UNITED STATES
DEPARTMENT OF THE INTERIOR
BUREAU OF LAND MANAGEMENTNMOCD Rec'd: 9/24/2020
Operator CopyFORM APPROVED
OMB NO. 1004-0137
Expires: January 31, 2018**SUNDRY NOTICES AND REPORTS ON WELLS**
Do not use this form for proposals to drill or to re-enter an abandoned well. Use form 3160-3 (APD) for such proposals.**SUBMIT IN TRIPLICATE - Other instructions on page 2**

7. If Unit or CA/Agreement, Name and/or No.
NMNM128925A8. Well Name and No.
ARTESIA YESO FEDERAL UNIT 79. API Well No.
30-015-40671-00-S110. Field and Pool or Exploratory Area
ARTESIA11. County or Parish, State
EDDY COUNTY, NM

OXY USA WTP LP respectfully requests approval to plug and abandon the subject well. Due to COVID and the economic environment, we request approval with an estimated date of work of August 2021. The plan is as follows:

OXY USA WTP Inc. - Current
Artesia Yeso Federal Unit #007
API No. 30-015-40671

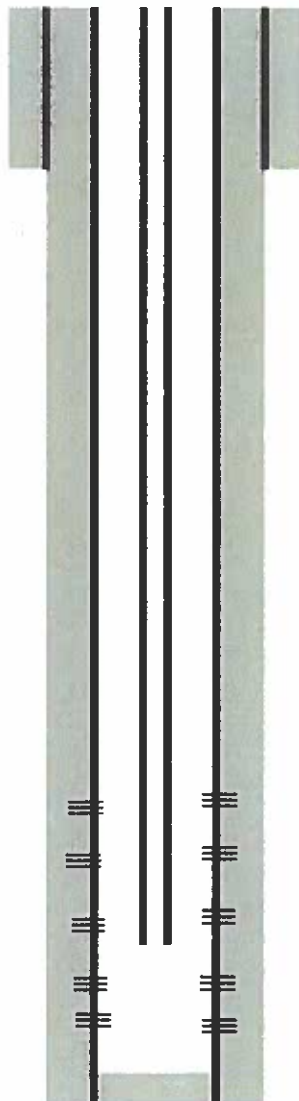
3. M&P 55sx class c cmt from ~~1977'~~ to 1572' WOC-Tag

2005-

OXY USA WTP Inc. - Proposed
Artasia Yeso Federal Unit #007
API No. 30-015-40671

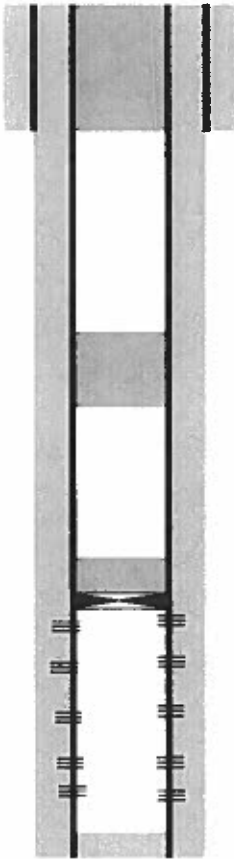
M&P 55sx from 1977' to 1572' - WOC - Tag
